SERVICE INFORMATION

NUMBER: 05-57-14

SUBJECT: Front Cross Member Mounting Bolt Change

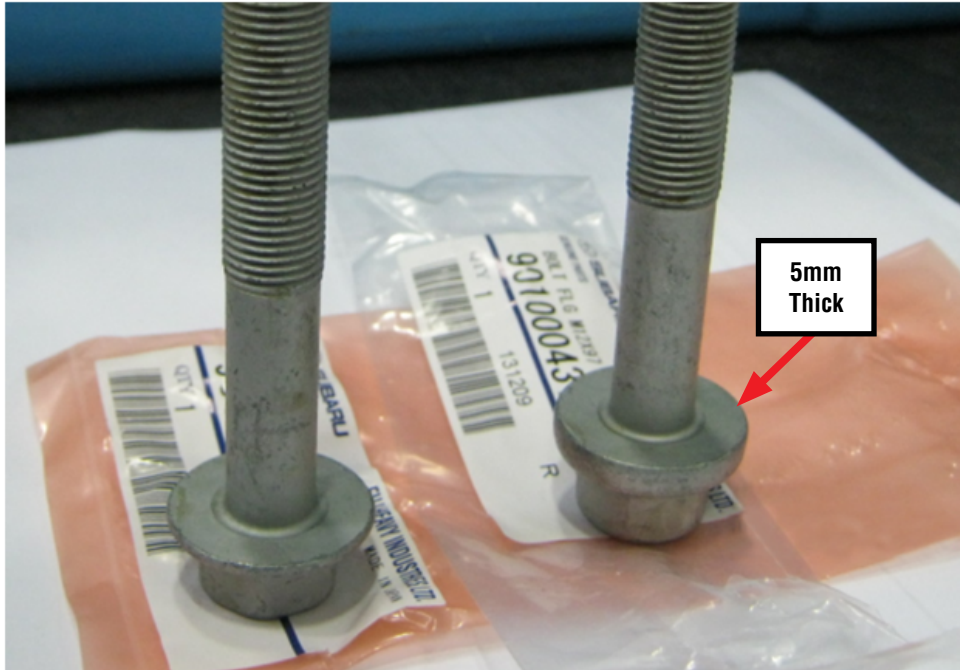
This bulletin describes a design change made to the mounting bolts used for securing the front cross member to the vehicle body. The flange thickness at the base of the bolt's hex portion has been increased from 1.4mm to 5mm.

The old-style bolt is shown below, left and the new style with the 5mm thick flange is on the right.

- These bolts have been designed for front cross member mounting only and are not compatible for other use in other areas of the vehicle.
- These bolts are **one-time use** items.
- The torque specification for all models listed above remains unchanged and is 95 Nm / 70.1 ft. lbs.
